September 12, 2011

**Document: Remedial Action and Operations & Maintenance Status Report July Through December 2010. Lowery Landfill Site.**

**Reviewer: CLLEAN**

Figure 1. Nitrate concentrations in B-313.

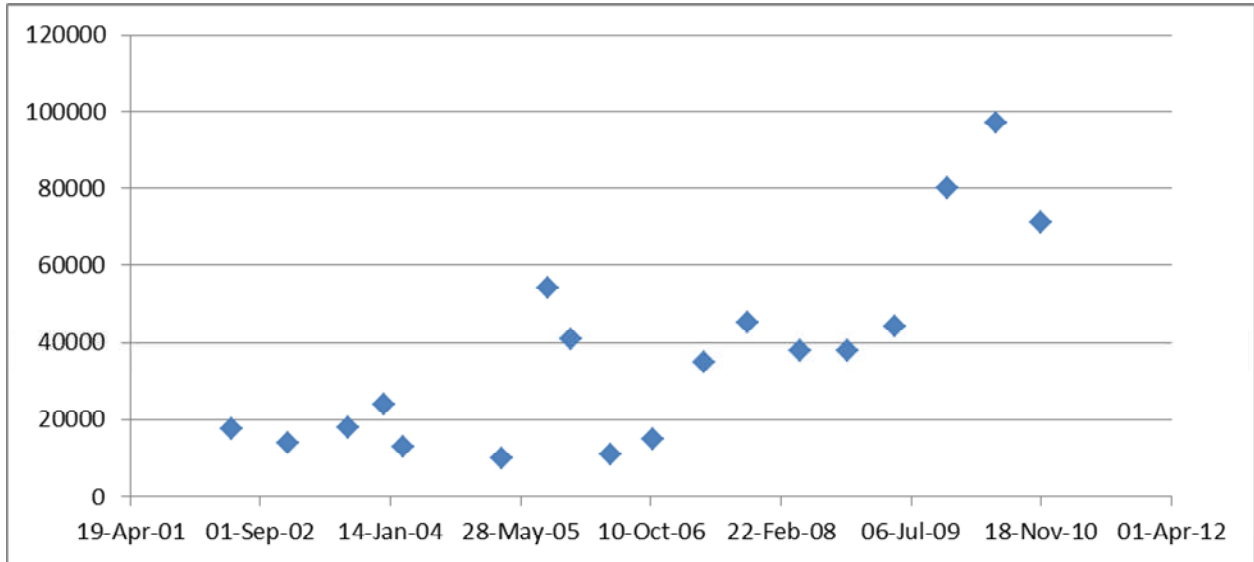
#	Section(s)	Page	Comment
12	4.4.2	18	The increasing nitrate concentration appears to be consistent with decreasing dissolved oxygen concentration (Figure 1 and Figure 2 below) this may indicate that the nitrate conditions are tempered by denitrification. This would also indicate that if nitrate was residual (no new addition) then concentrations would likely be stable or decreasing. This issue should be added to this discussion. Since both nitrate and 1,4-dioxane are water soluble, there is likely a relationship between the persistent 1,4-dioxane concentrations and increasing nitrate at this location.
13	4.4.2	Table 4.5	Table 4.5 has trend labeled as “decreasing” for parameters/wells also marked “insufficient data”. Similar to the comment regarding trend above, with no reference to a statistical method within the GWMP, this label is not appropriate. It would be correct to leave the trend box blank, indeterminate or reference the text for discussion. This conclusion is also somewhat vague considering the Groundwater Monitoring Plan only provides two descriptions for trends for compliance wells; “increasing” and “not increasing”. (Appendix C, pg. 8, Groundwater Monitoring Plan Revision Number 1, December 28, 2005).
